CITY OF AUSTIN
Board of Adjustment/Sign Review Board
Decision Sheet

CASE NUMBER: C15-2014-0163

ADDRESS: 1303 East 2ND ST

City of Austin Residential Permit Application Master Comment Report

1 East
1/8" = 1'-0"

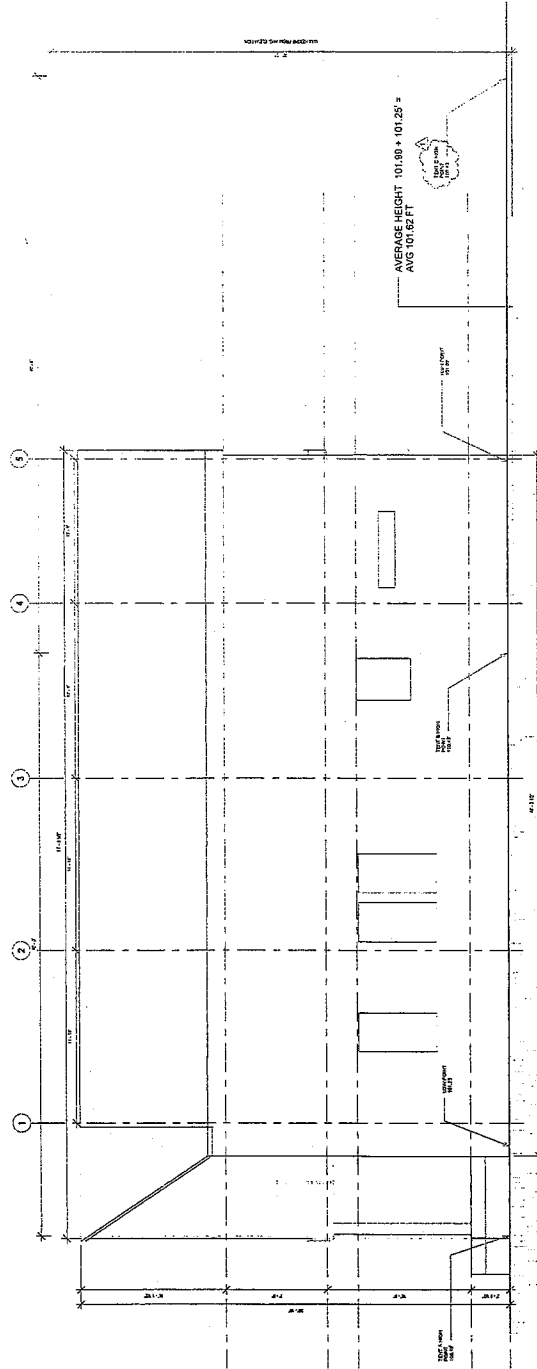
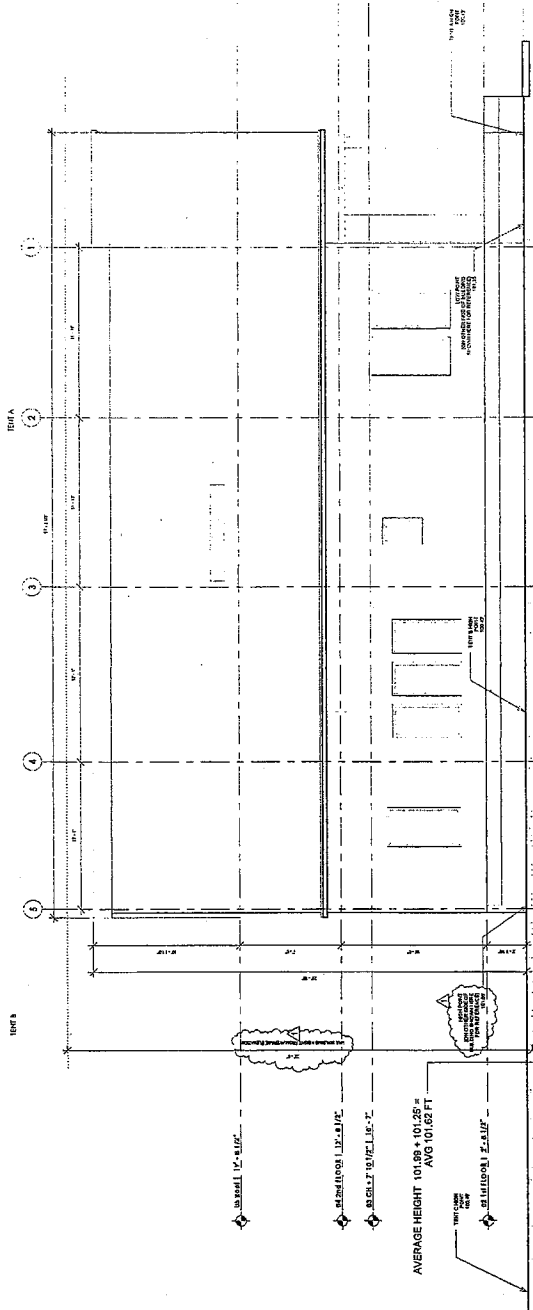
I would also like to explain the unusual design that this variance would allow. Right now, the eastern wall of our neighbors' home—which faces our house—is one story tall, topped with a gabled roof that slopes down toward the lot lines. Were the variance to be granted, that wall would turn into a shear, two-story wall facing our house with a shed roof pitching west. Given how close our neighbors' home sits to ours—less than fourteen feet apart—this would affect us in a profound way.

How would this monolithic two-story structure affect us? Here are a few examples:

- Our kitchen's and dining room's sole windows are on our western wall. The natural light in those rooms will be vastly diminished, if not blocked all together.
- Our living room, which also has a western window, will be dramatically affected as well. We fear that its natural light will be completely obstructed by the carport that my neighbors intend to build right up to the property line.
